**Palo Verde
Nuclear Generating Station**
5871 S. Wintersburg Road
Tonopah, AZ 85354
Tel: (623) 393-2488

Subject: **Palo Verde Nuclear Generating Station (PVNGS) Unit 1
Docket No. STN 50-528
Unit 1 Core Operating Limits Report Revision 31**

**Unit 1 Core Operating Limits Report
Revision 31**

Revision 31

FIGURE 3.2.4-2
 DNBR MARGIN OPERATING LIMIT BASED ON
 THE CORE PROTECTION CALCULATORS
 (COLSS OUT OF SERVICE, CEAC(s) OPERABLE)

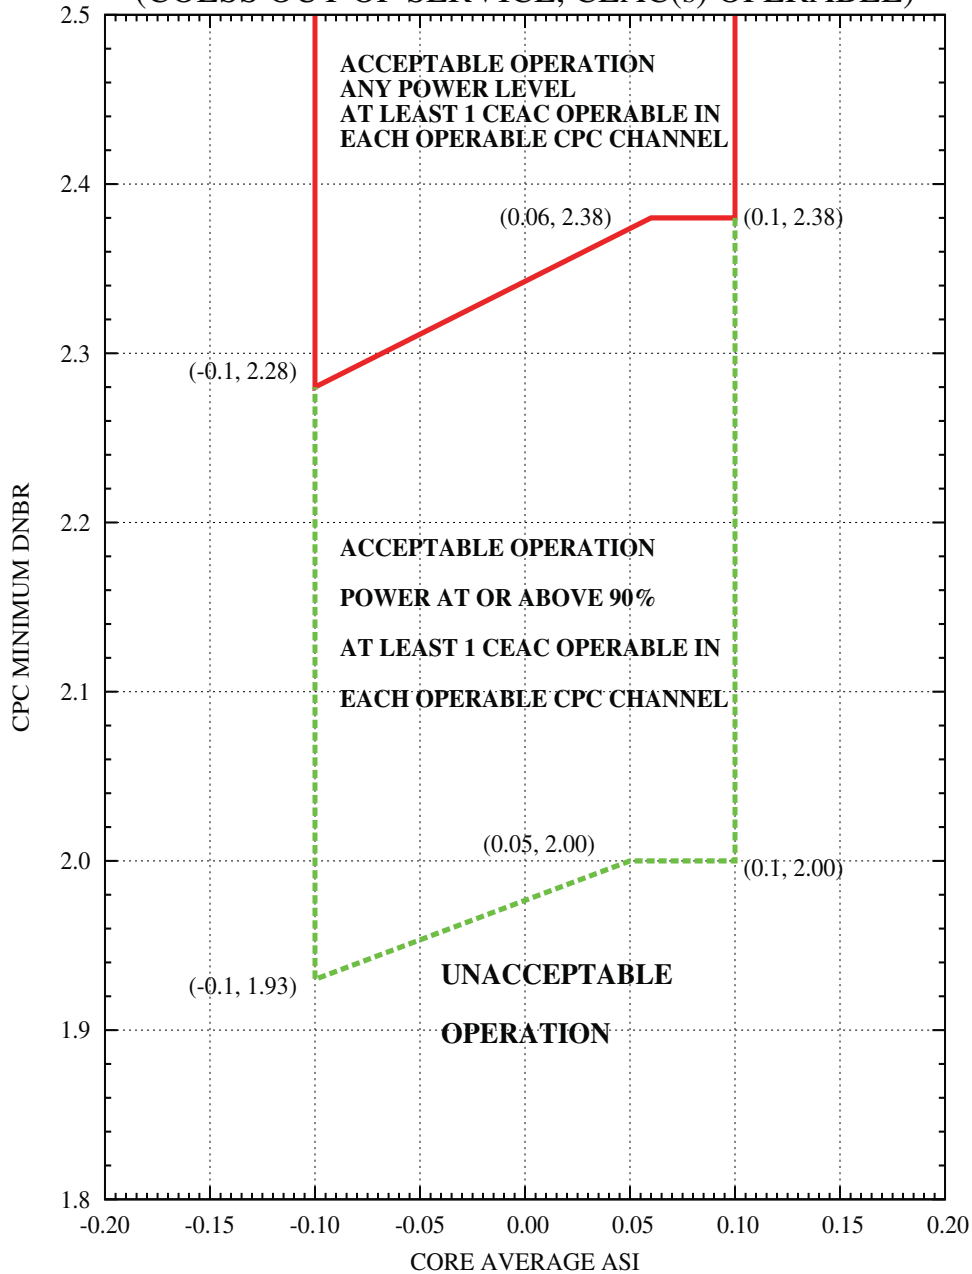
The changes implemented by the revision are to Section 3.2.1, *Linear Heat Rate (LHR)* and Figure 3.2.4-2, *DNBR Margin Operating Limit Based on the Core Protection Calculators*. Specifically, the linear heat rate limit is a constant 13.1 Kw/ft throughout the cycle, because of completing the Westinghouse Next Generation Fuel (NGF) transition cores. Revision bars have been applied to those pages which contain changes.

COLSS OUT OF SERVICE and CEAC(s) OPERABLE - Operate within the region of acceptable operation of Figure 3.2.4-2 using any operable CPC channel.
